TARGET DEVELOPMENT
ON MONTGOMERY BLVD.
PUBLIC IMPROVEMENTS

PROJECT NUMBER
3407

CITY OF ALBUQUERQUE PUBLIC WORKS DEPARTMENT ENGINEERING GROUP					
TITLE: WATER DISTRIBUTION PLAN FOR TARGET DEVELOPMENT ON MONTGOMERY BLVD. N.E.					
APPROVALS	ENGINEER	DATE	APPROVALS	ENGINEER	DATE
City Engineer	<i>[Signature]</i>	12/13/97	Liquid Waste	<i>[Signature]</i>	12/13/97
A.C.E. Design	<i>[Signature]</i>	12/13/97	Traffic	<i>[Signature]</i>	12/13/97
A.C.E. Hydrology	<i>[Signature]</i>	12/13/97	Water	<i>[Signature]</i>	12/13/97
DRAWING NO.	3407	MAP NO.	G-20	SHEET	5 OF 16

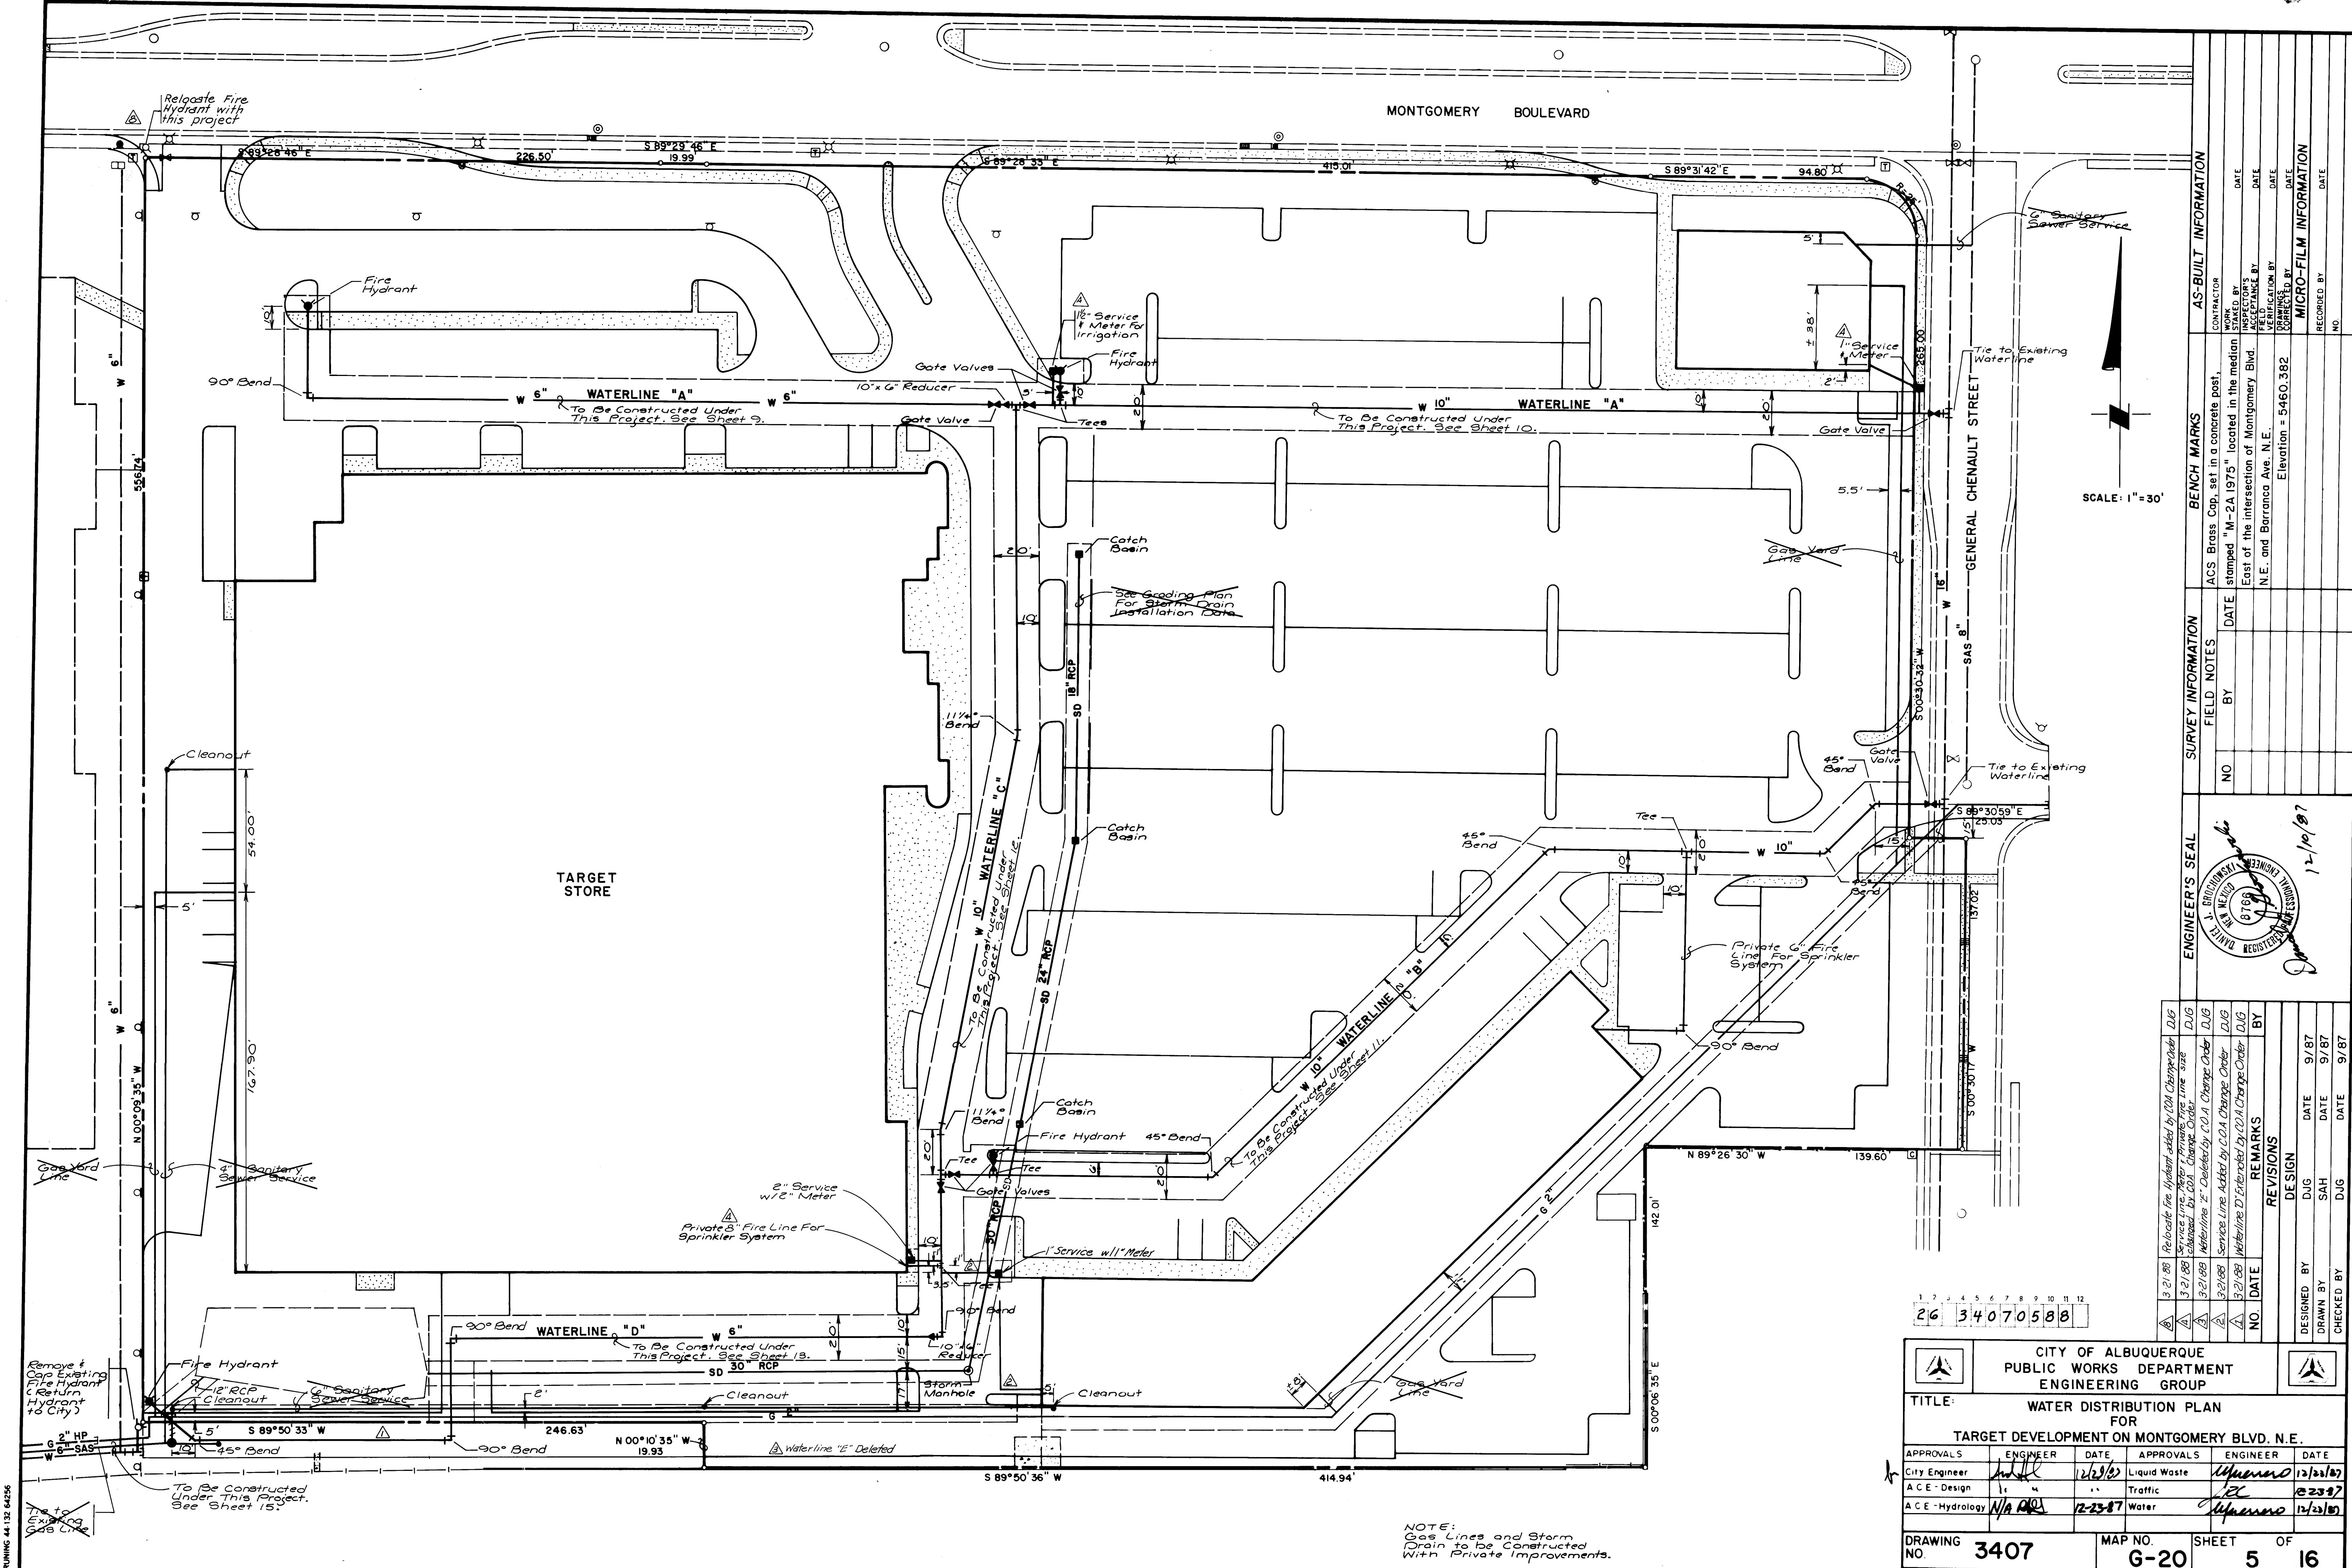
NO.	DATE	REMARKS	BY
1	3/21/88	Relocate Fire Hydrant Added by C.O.A. Change Order	DUG
2	3/21/88	Service Line Private Fire Line Line Deleted by C.O.A. Change Order	DUG
3	3/21/88	Waterline 12" Deleted by C.O.A. Change Order	DUG
4	3/21/88	Service Line Added by C.O.A. Change Order	DUG
5	3/21/88	Waterline 12" Extended by C.O.A. Change Order	DUG
